# UNITED STATES PATENT AND TRADEMARK OFFICE

APPLICATION NO.	FILING DATE	FIRST NAMED INVENTOR	ATTORNEY DOCKET NO.	CONFIRMATION NO.
10/051,869	01/16/2002	John L. Waddell	61624-3	7913

<b>Office Action Summary</b>	<b>Application No.</b> 10/051,869	<b>Applicant(s)</b> WADDELL, JOHN L.	
	<b>Examiner</b> Hadi Shakeri	<b>Art Unit</b> 3723

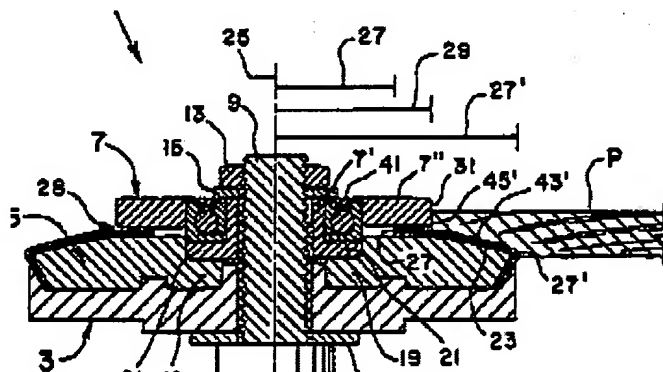
5. Claim 12 is rejected under 35 U.S.C. 102(b) as being anticipated by Casillas et al. (5,394,652).

Casillas et al. discloses all of the limitations of claim 12, i.e., a profile wheel (5) having portions with first (27) and second diameters (27') and a rub collar or guide wheel (7) with a third diameter (29) smaller than the second diameter and larger than the first; and a bearing (41) coupled to the guide wheel and the shaft (9).
